CITY OF ALBUQUERQUE

RE: **Explore Academy**
5100 Masthead NE
Grading and Drainage Plan
Engineer's Stamp Date 2/26/18
Hydrology File: D17D003N

PRELIMINARY
GRADING PLAN

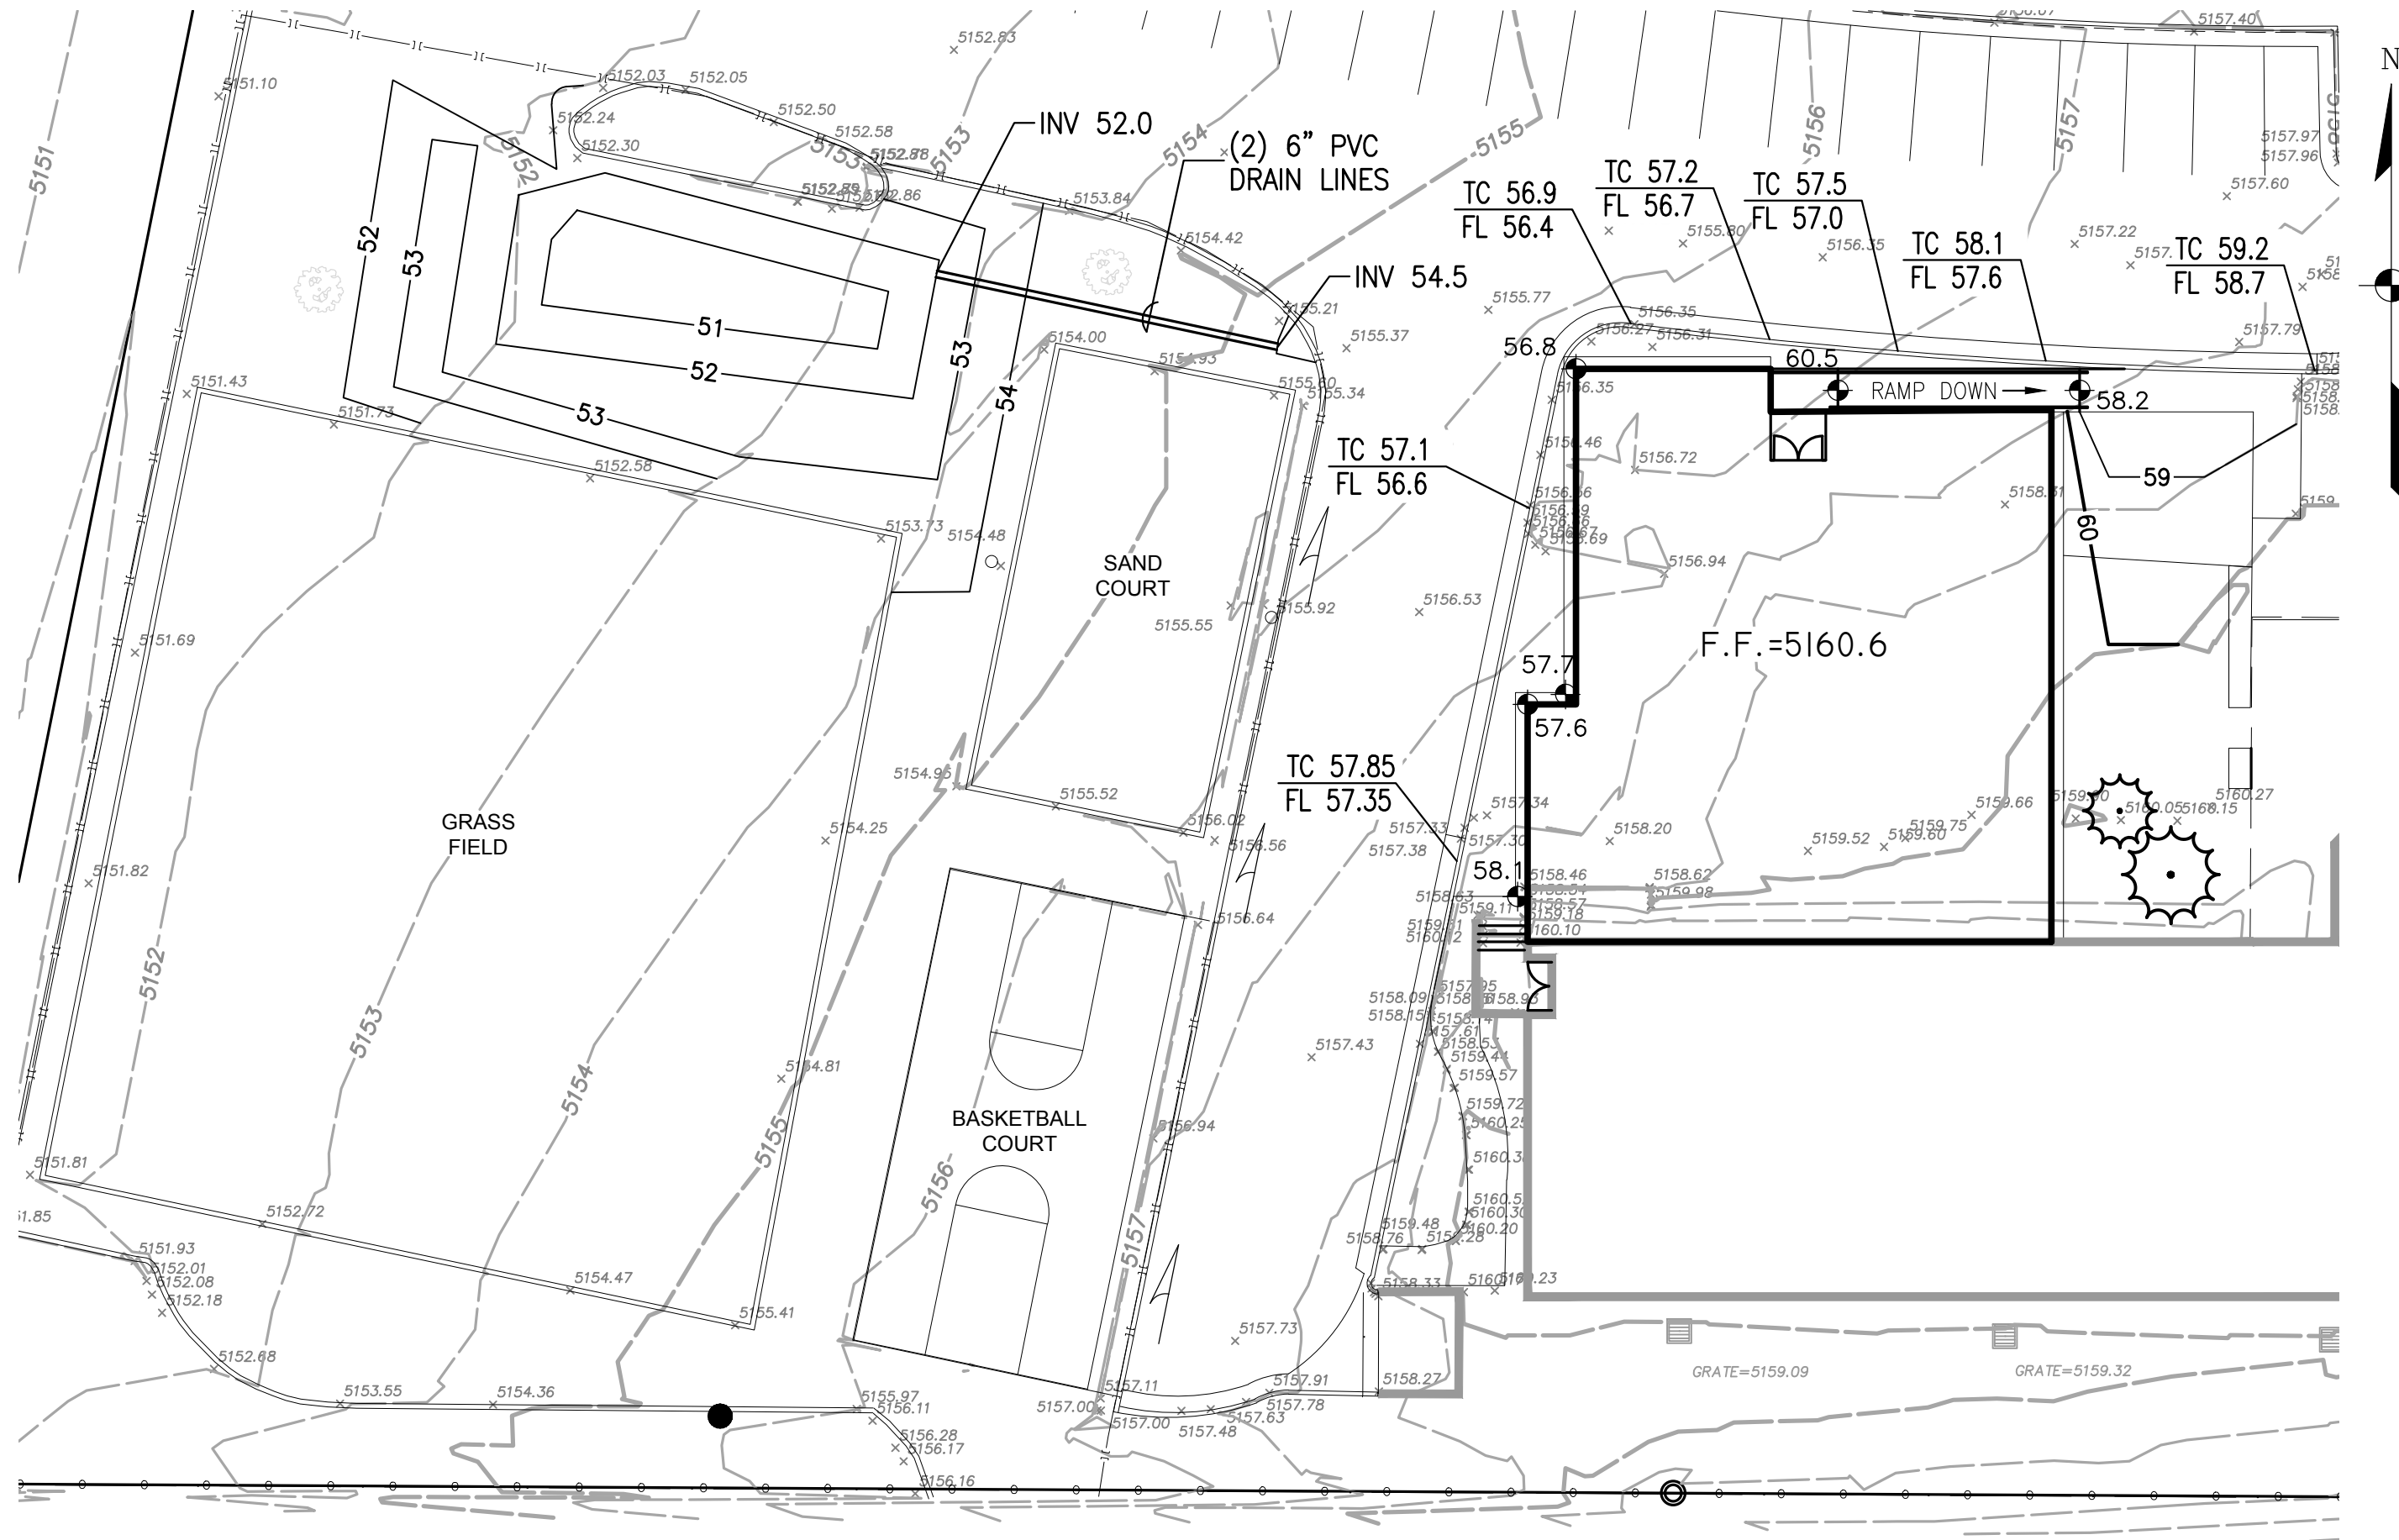
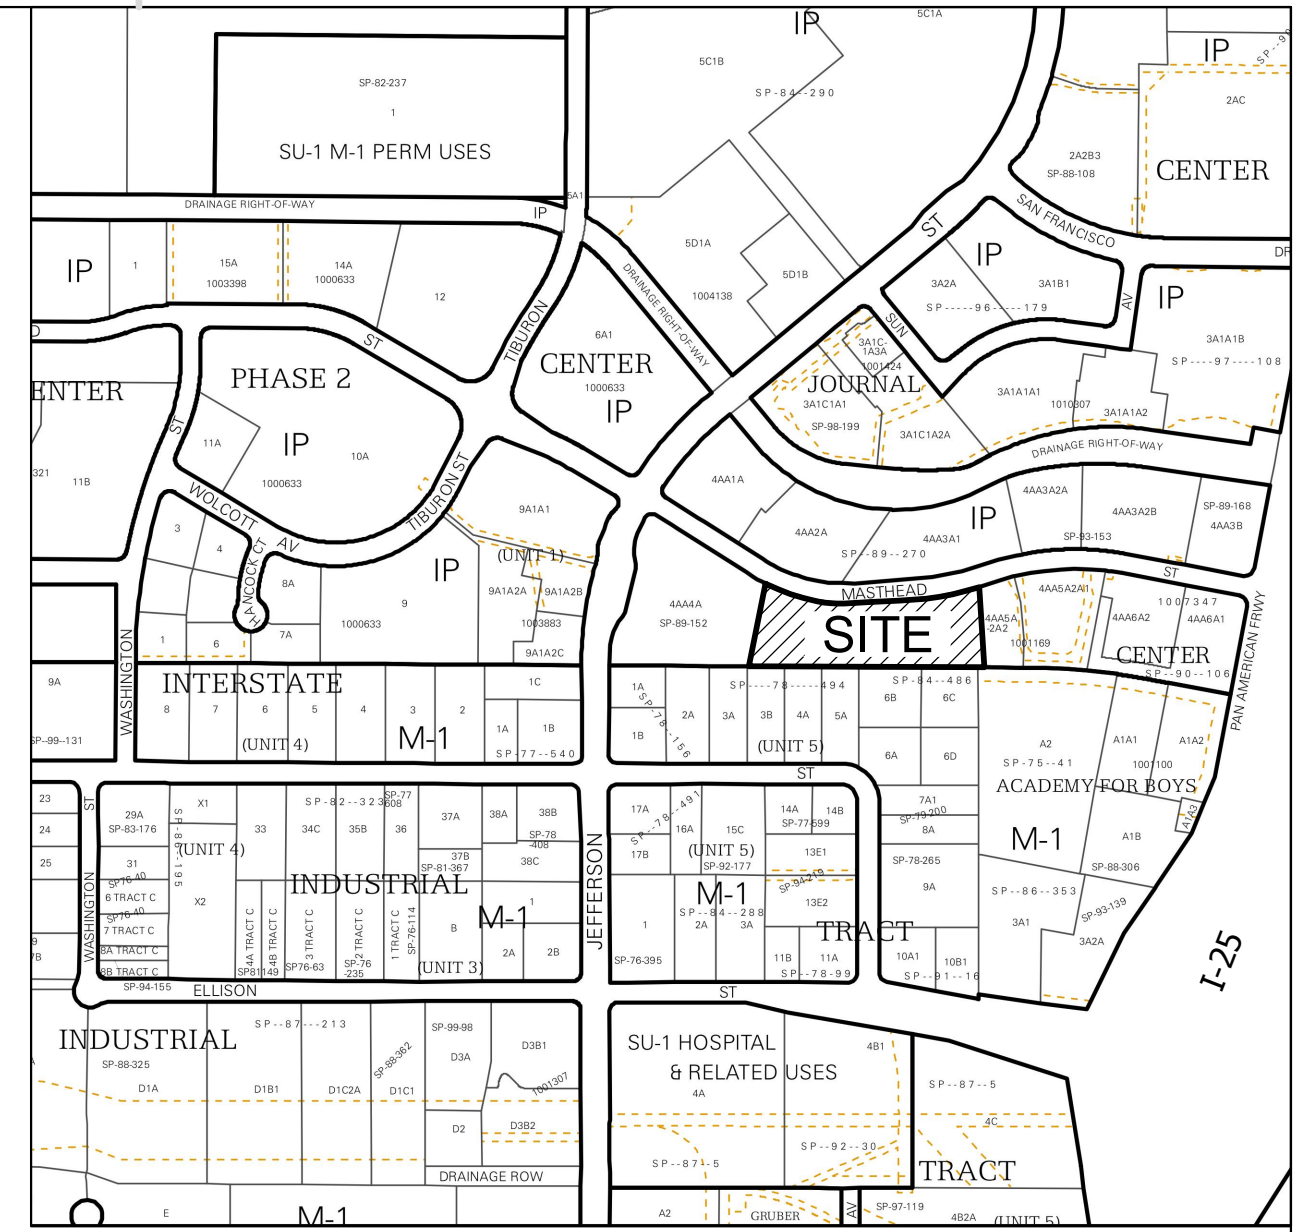
3. Runoff calculations appear to be using land treatment B for multiple zones, instead of zone 2 for the various land treatments, Please correct accordingly.
4. Provide a detail for the 6" pipe inlets. Will these have a concrete apron and end section? Will they be grated? Will there be a local depression to prevent bypass flows?
5. A Private Facility Drainage Covenant is required for the stormwater quality pond. The original notarized form, exhibit A (legible on 8.5x11 paper), and recording fee (\$25, payable to City of Albuquerque) must be turned into DRC (4th, Plaza del Sol) for routing. Please contact Charlotte LaBadie (clabadie@cabq.gov, 924-3996) or Madeline Carruthers (mtafoya@cabq.gov, 924-3997) regarding the routing and recording process for covenants.

GRADING AND DRAINAGE PLAN
WEST ADDITION

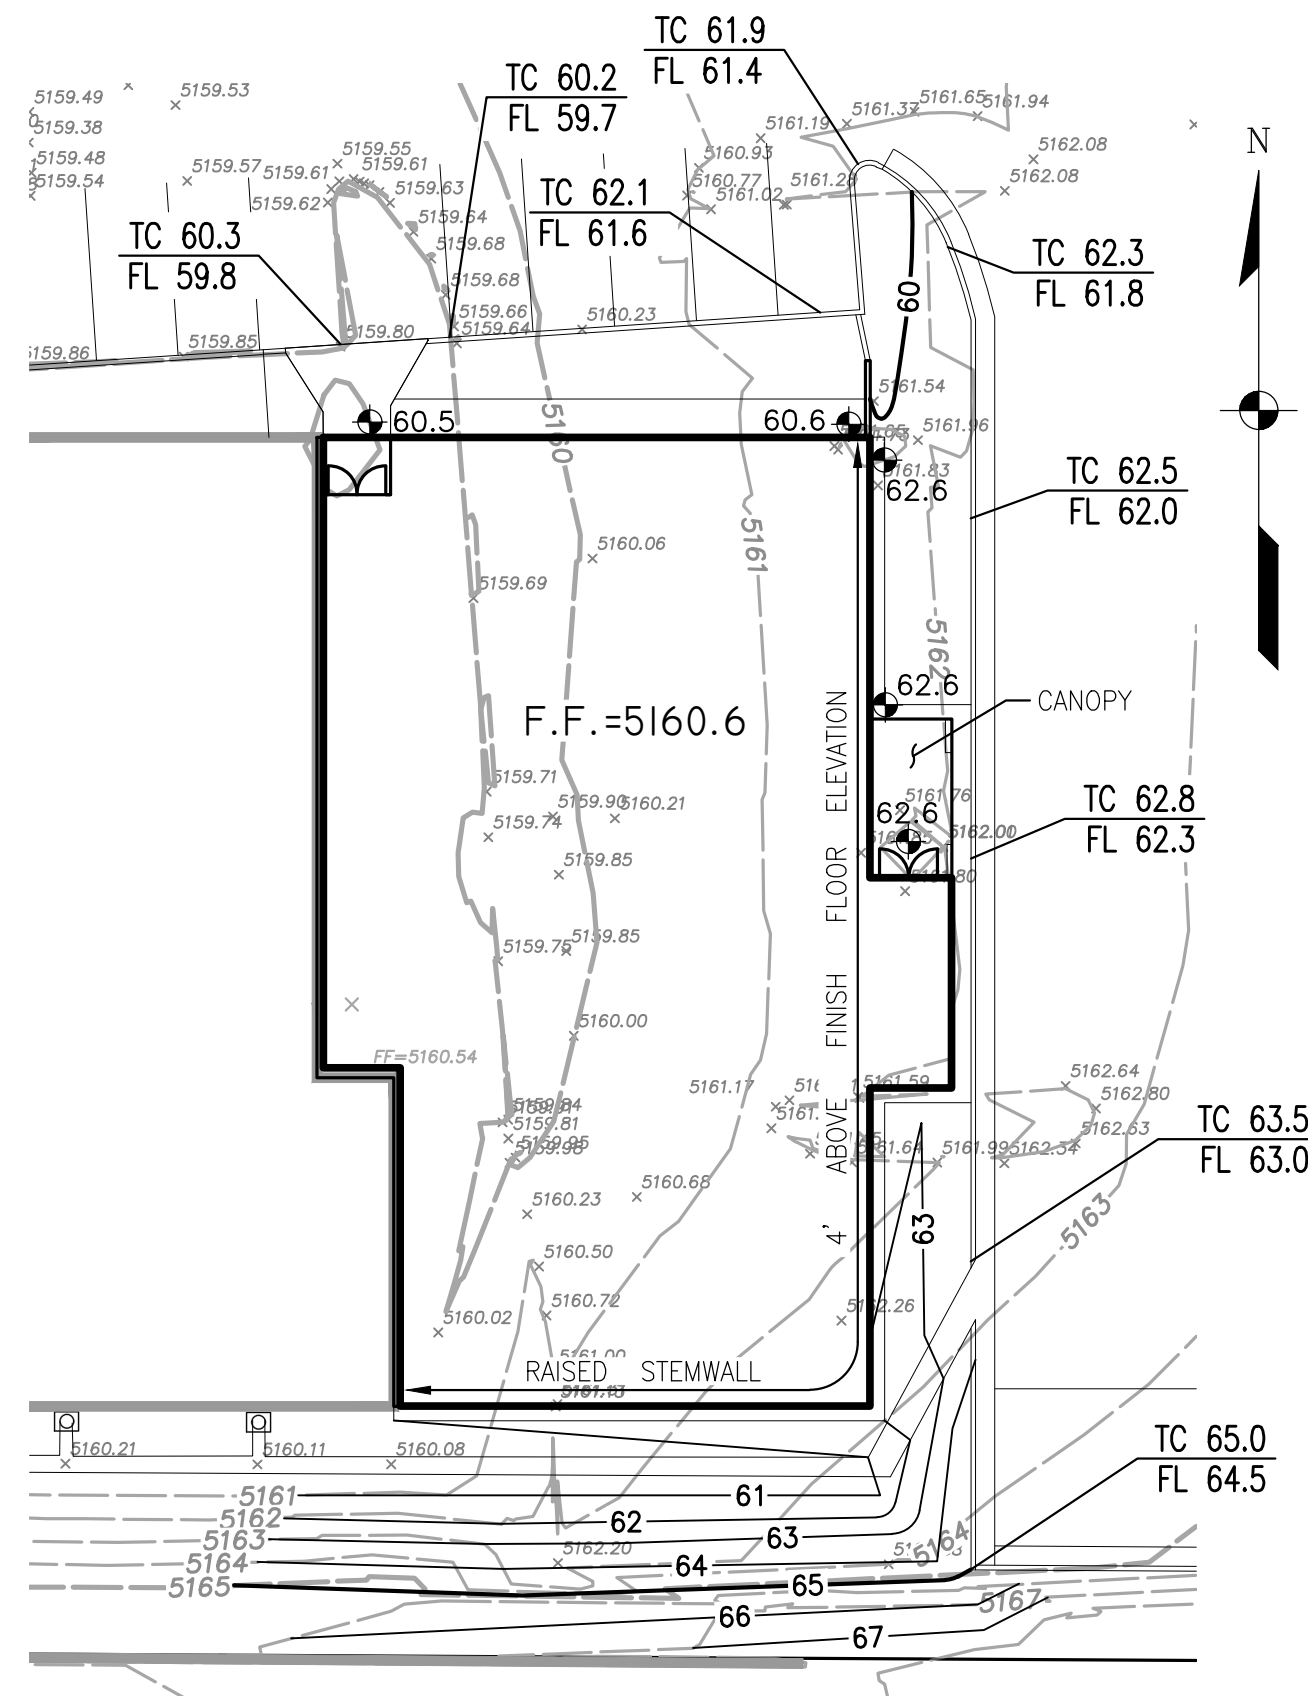
1. Delineate the subbasin that drains into the proposed pond. Demonstrate that the pond captures runoff from at least 9,950 SF of impervious area within the boundary of this parcel (equal to the first flush requirement for this re-development).
2. If not requesting Building Permit at this time, the Grading Plan needs to be labelled as "Conceptual, not for Construction" or similar. If requesting SPBP and Building Permit with this Grading Plan, forgo the conceptual markings and correct the following Building Permit items as well:
